# CITY OF BUCKLEY

## Staff Report and Recommendation

### Cottage Housing Subdivision S-CH 3089 Couls Cottages

**To.** Hearing Examiner  
**From.** City Planner  
**Subject.** Staff Advisory Report. Conditional Use Permit Findings, Conclusions, and Recommendations  
**Hearing.** Tuesday, November 15, 2016, 3 p.m.  
City of Buckley Multi-Purpose Center  
811 Main Street  
Buckley, WA 98321  
**Issues.** Increased density on a confined lot surrounded on three sides by existing residences.

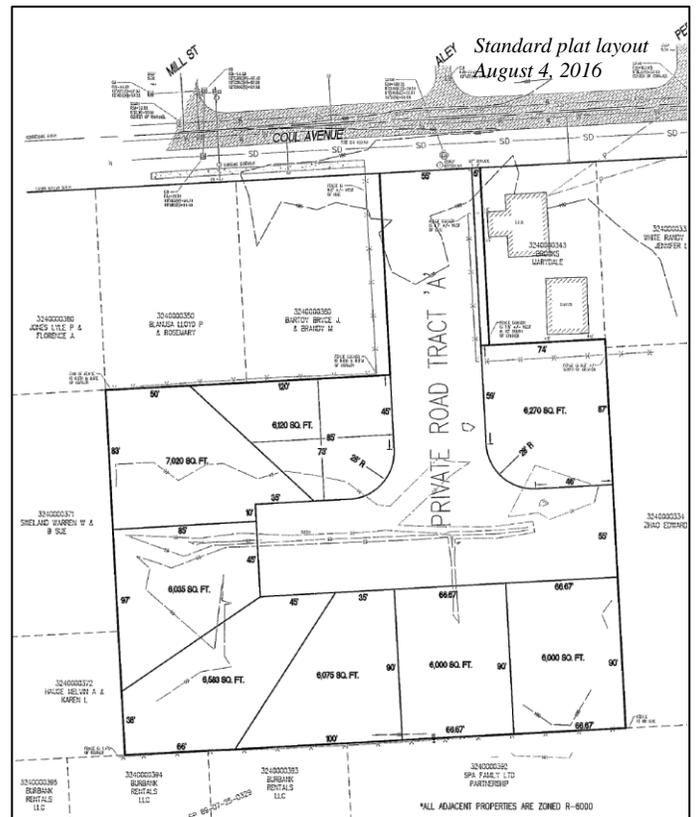
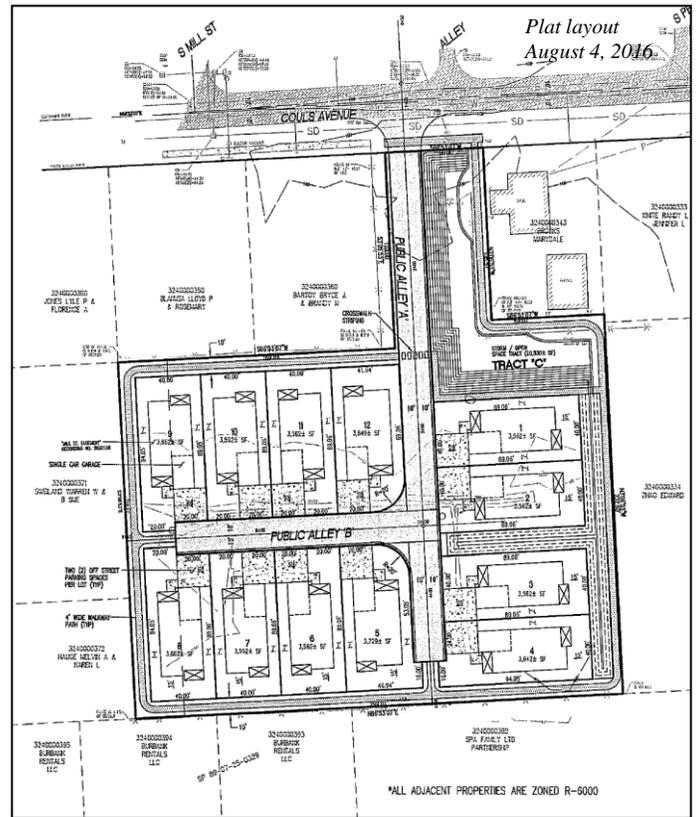
- c. A hydrant will be required within the lot, and 20 feet width of paving will be required for the driveway/public alley.
- d. Details of the proposal are as follows:
  - i. Twelve lots at about 3,606 sf in size.
  - ii. Single-story single family houses with one-car garages; the houses will be about 1,009 sf and also will contain a 260 sf garage and two porches of 78 sf each (156 sf total).
  - iii. A perimeter trail will be provided and total about 1,244 lineal feet (lf); the trail will be placed in easements five and 10 feet wide.
